DECam CD-1

Focal Plane Detectors and CCD Camera

DECam CCDs

2) Yield (continued)

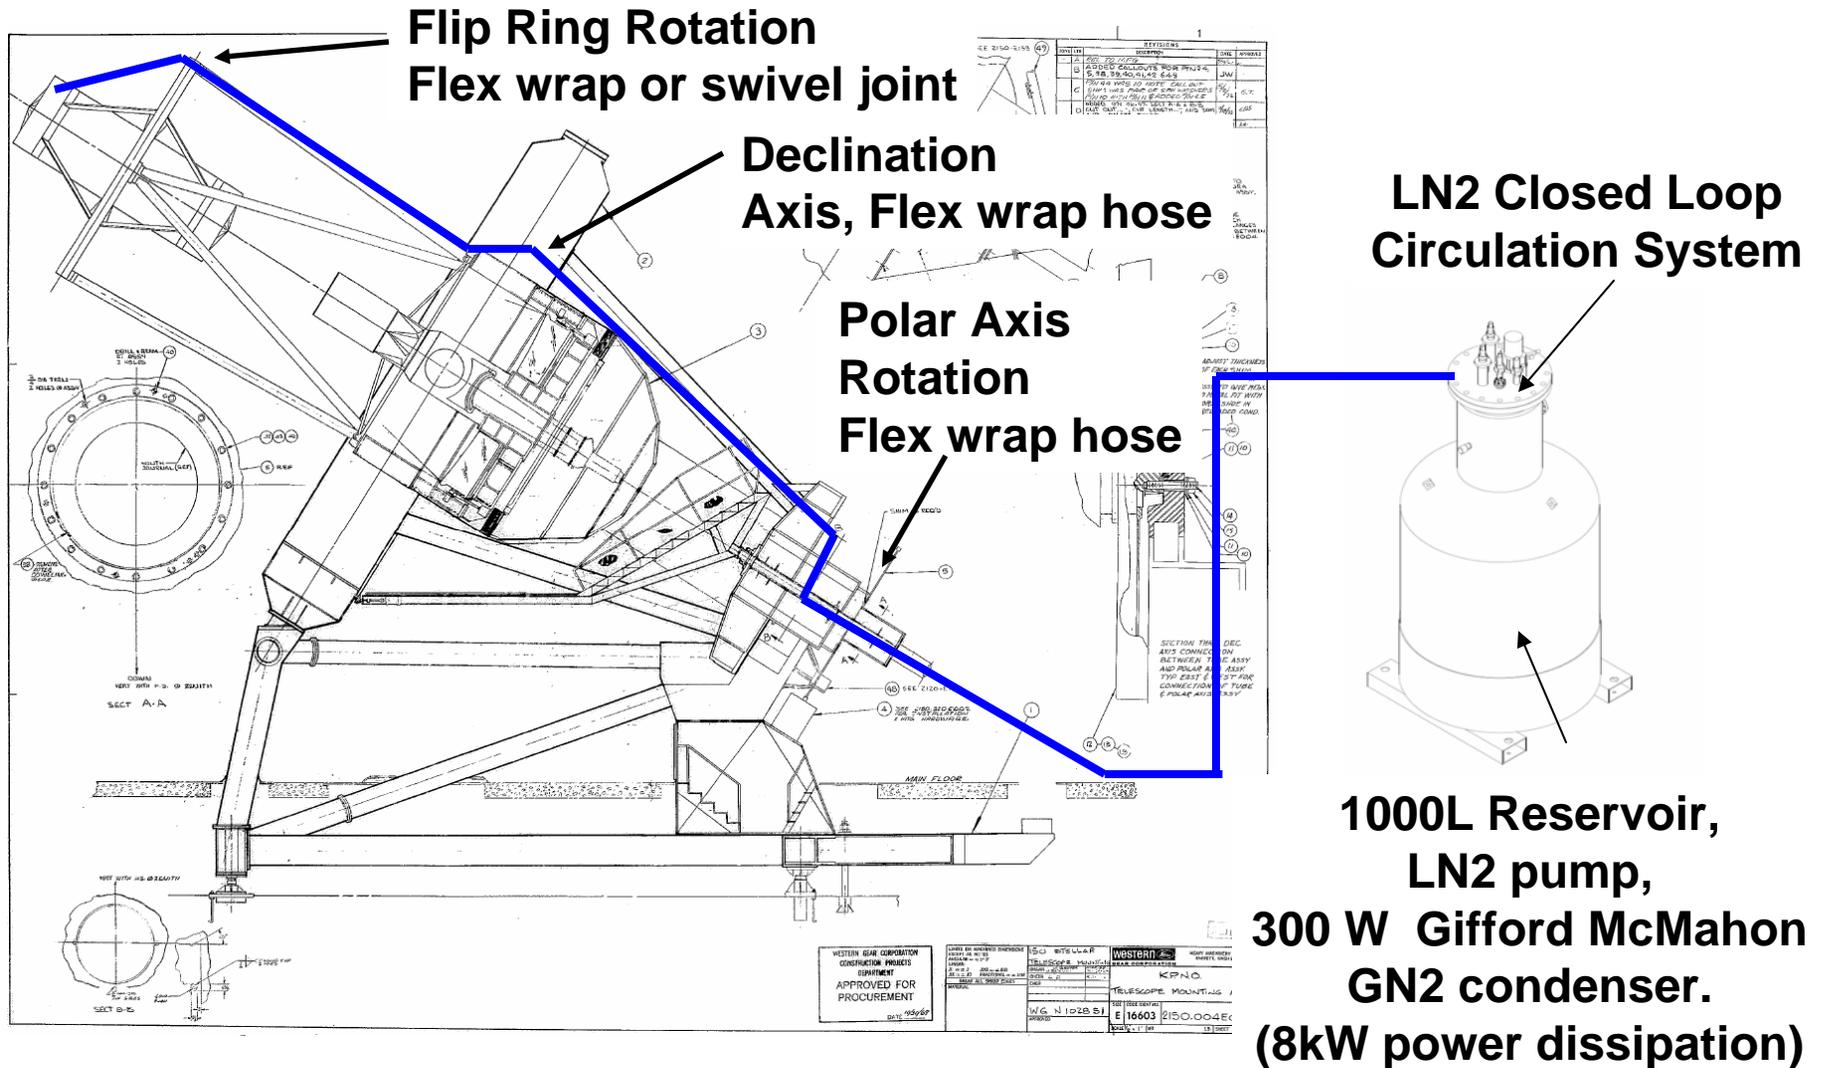
Examples of how cosmetic specs may be relaxed:

- “Carbon trading”: specify cosmetic defects as an average across the entire focal plane rather than across a single detector. Allow increase in bad pixels/columns on some CCDs if others are better than the requirement.
- Determine how much of the image area is deemed to be lost due to a single bad pixel or columns versus a contiguous cluster. Does a single bad column count as 4 columns lost due to the width of the PSF? (Do two contiguous bad columns count as 5 lost.)
- Alternatively does the requirements flow down take into account the recovery of bad pixels by dithering? I.e. are bad columns like gaps between CCDs?

4. Work with science team to develop a more sophisticated measure of performance yield. A formal process should be initiated to update the science requirements flow down, which should be under change control.
